Your Reference: SSD 16\_7642  
Our Reference: NCA/8/2016  
Contact: Myfanwy McNally  
Telephone: 9806 5447

**Re: Central Acute Services Building Westmead Hospital, Hawkesbury Road, Westmead NSW 2145**

Forecourt Level 2  
Landscape Plan

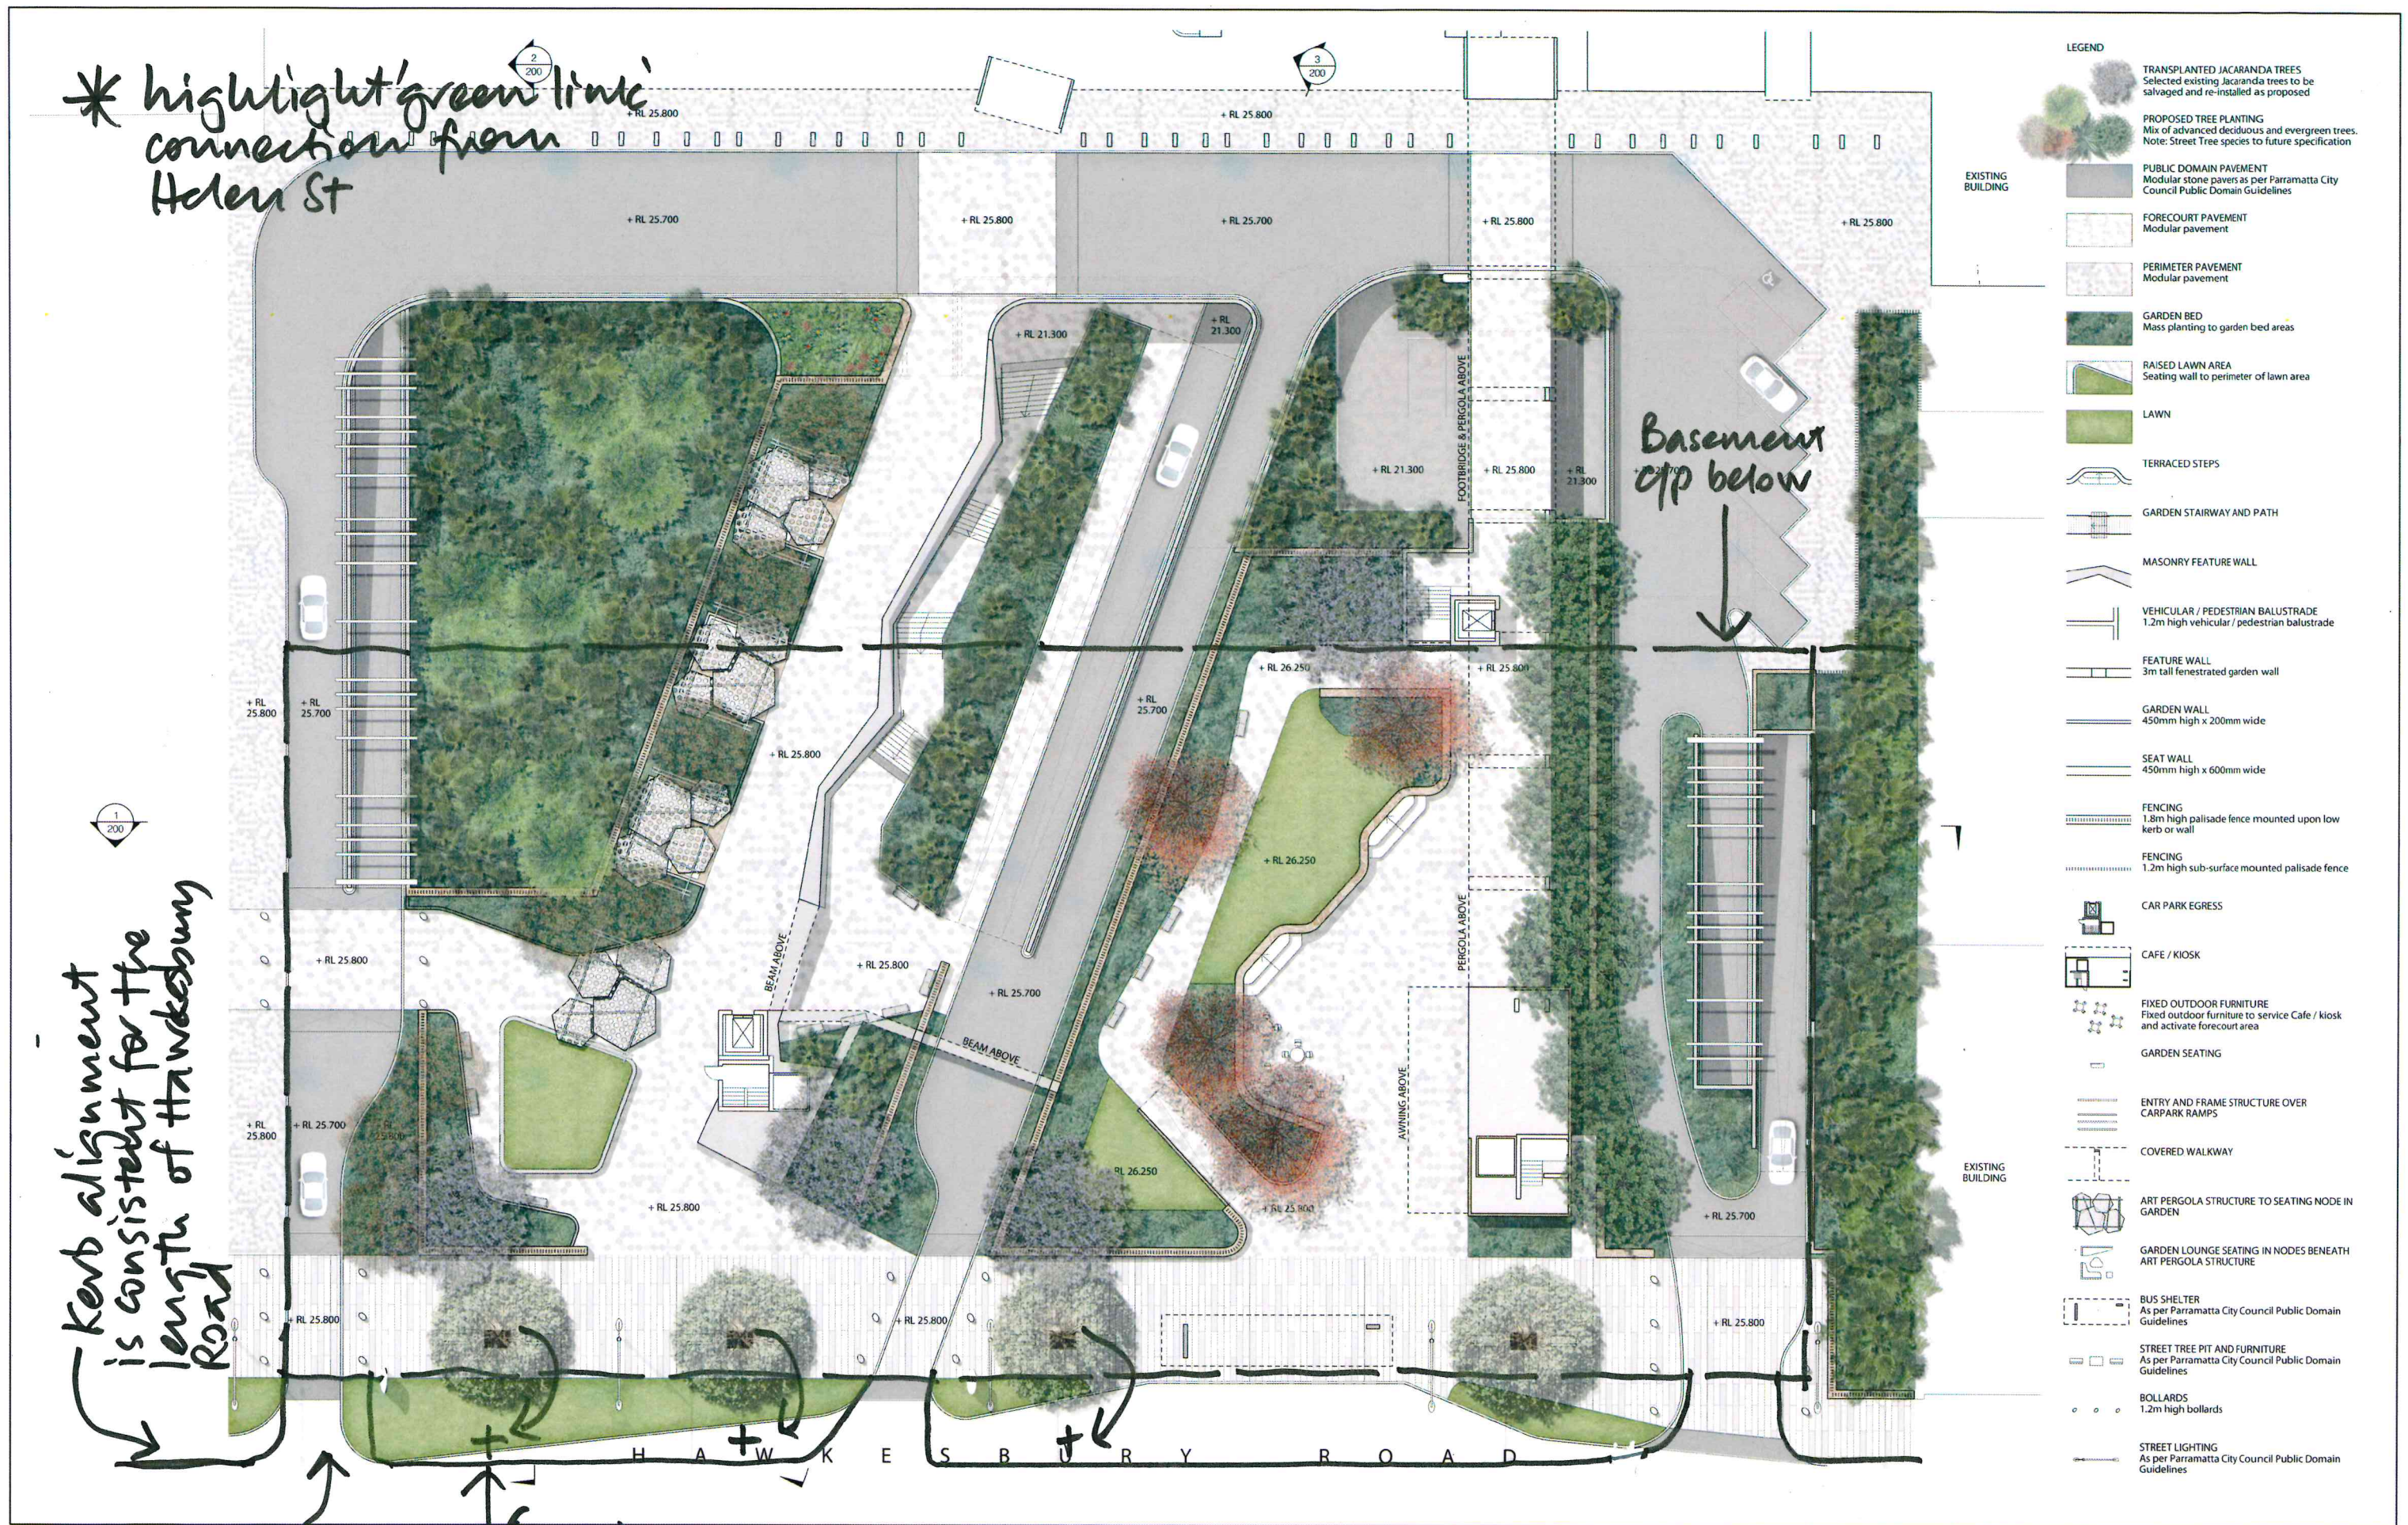
\* highlight green line connection from Helen St

Kerb alignment is consistent for the length of Hawkesbury Road

Clear hierarchy of driveway entries

(Large) Trees located in public verge on deep soil

**Forecourt  
Detail Sectional Elevations**

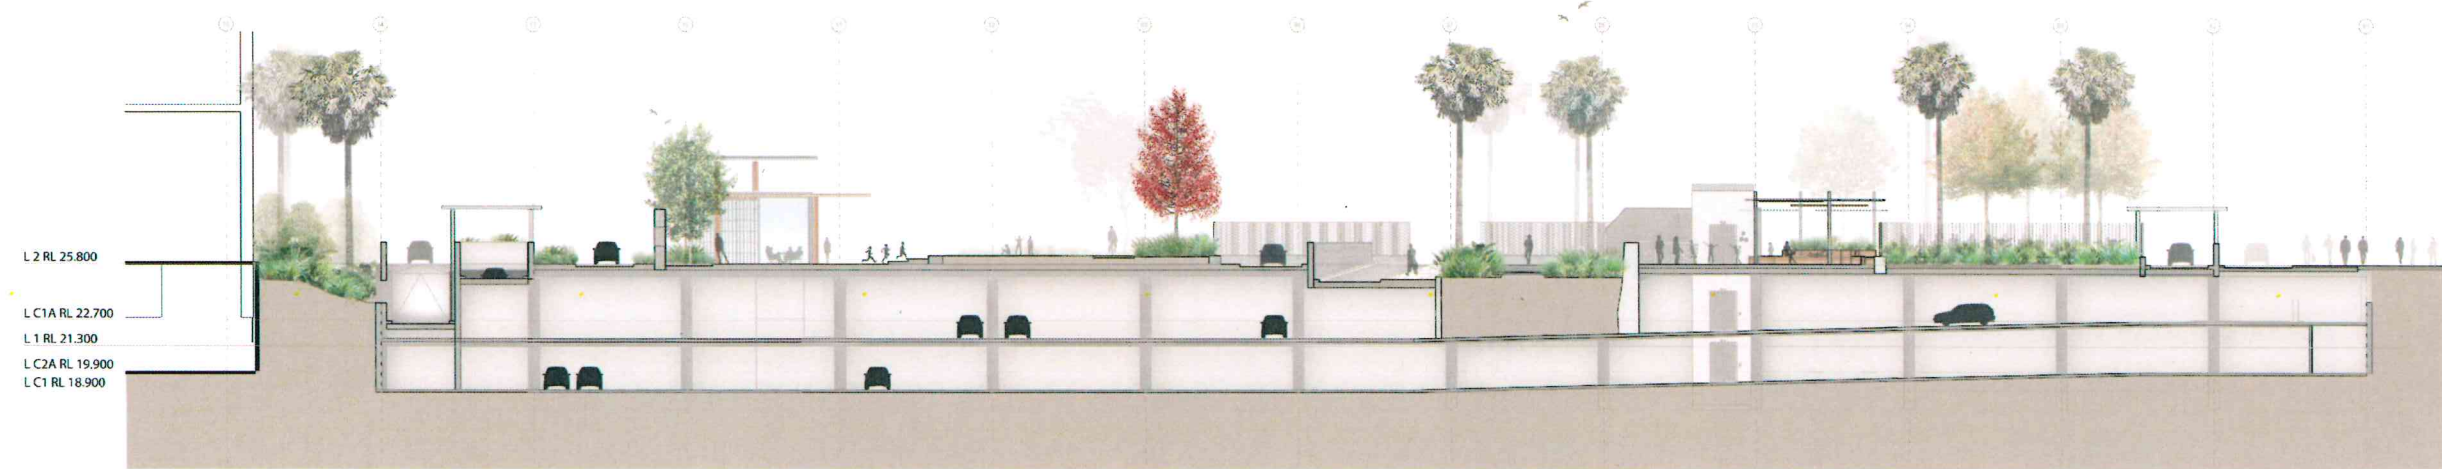
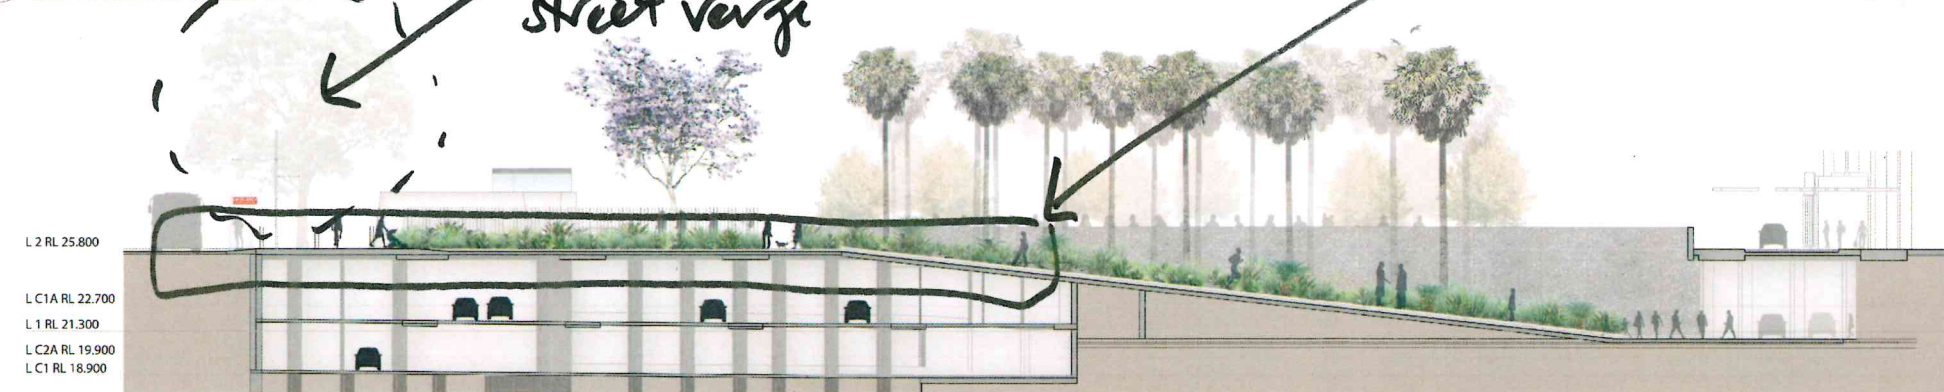
Plan to provide significant soil depth above car parking to support any significant entry forecourt landscape.

**Laneway Level 1  
Landscape Plan & Section**

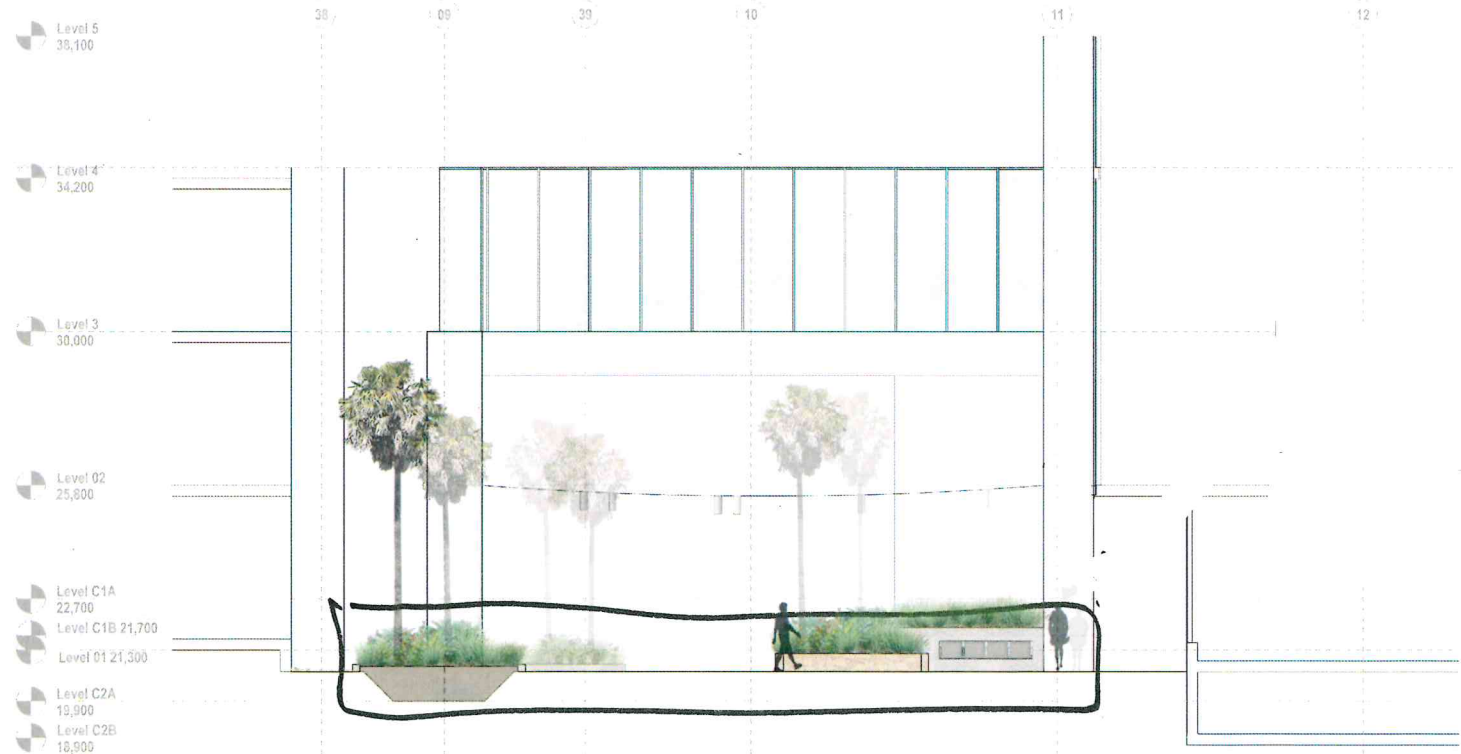
Provide landscape plans showing design resolution to the north of the proposal.

Extent of building over is unclear. Building over columns?
